5108

**PARKING SURFACE AND DRIVEWAY WIDTH
VARIANCES TO ALLOW AN AGGREGATE SURFACE
AND A 9' WIDE DRIVEWAY; ALL ACCESS AND
MANEUVERING AREA MUST BE ASPHALT, CONCRETE
OR AN ALTERNATIVE PARKING SURFACE AND ONE
WAY DRIVES MUST BE A MINIMUM OF 12' WIDE IN A
B-4, GENERAL BUSINESS DISTRICT**

653 & 659 SAINT FRANCIS STREET

BOARD OF ZONING ADJUSTMENT

SITE PLAN

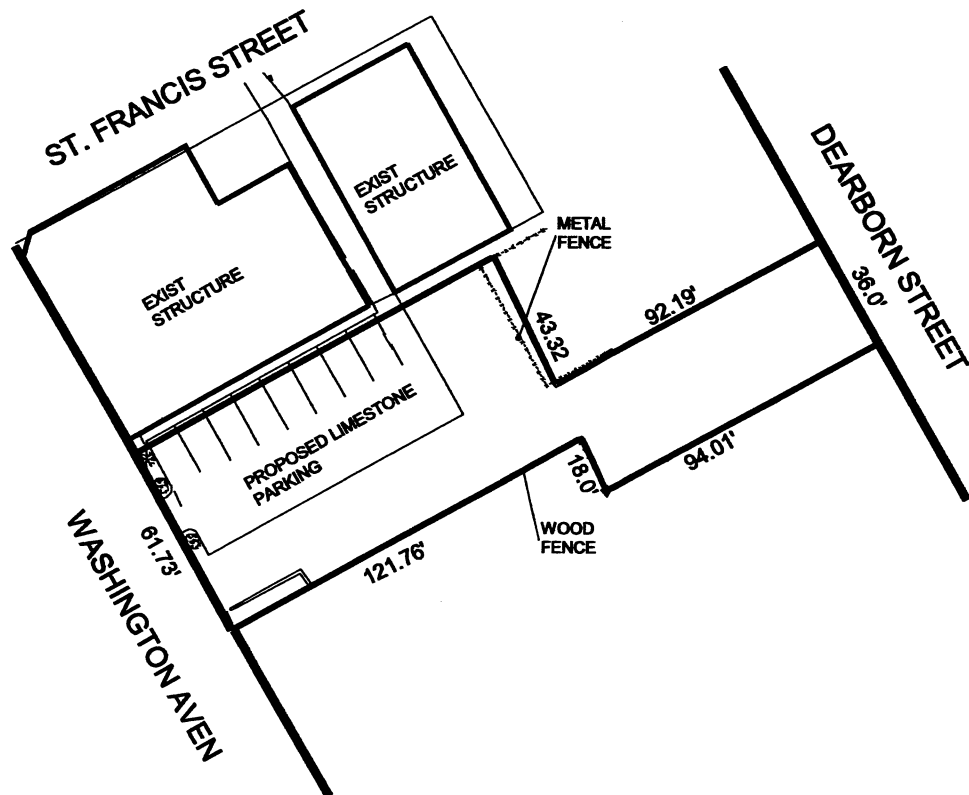
Access to the proposed parking facility is to be via an existing 9' wide paved alley between 655 and 659 St. Francis Street, and a new 12' wide drive to Washington Avenue. The Traffic Engineering Department has concerns about the access as shown on the plan submitted, and recommends that access to St. Francis be denied and that access to Washington Avenue be via a 24' two-way drive.

While there are some perceived advantages to crushed limestone parking lots (cost, aesthetics, drainage), there are also disadvantages such as the inability to delineate spaces, migration of the aggregate material, potential damage to vehicles. Also, after several years of use crushed limestone becomes "compacted", forming an impervious surface that is not beneficial for drainage.

Furthermore, there are other alternative parking surfaces allowed by the Zoning Ordinance that also meets most of the needs and desires of the applicant. These options include interlocking pavers, porous asphalt or grasscrete. Any of these surfaces could be allowed without requiring a variance, and some would probably be acceptable to the Architectural Review Board without much debate.

Based on the preceding, it is recommended that this application be denied.
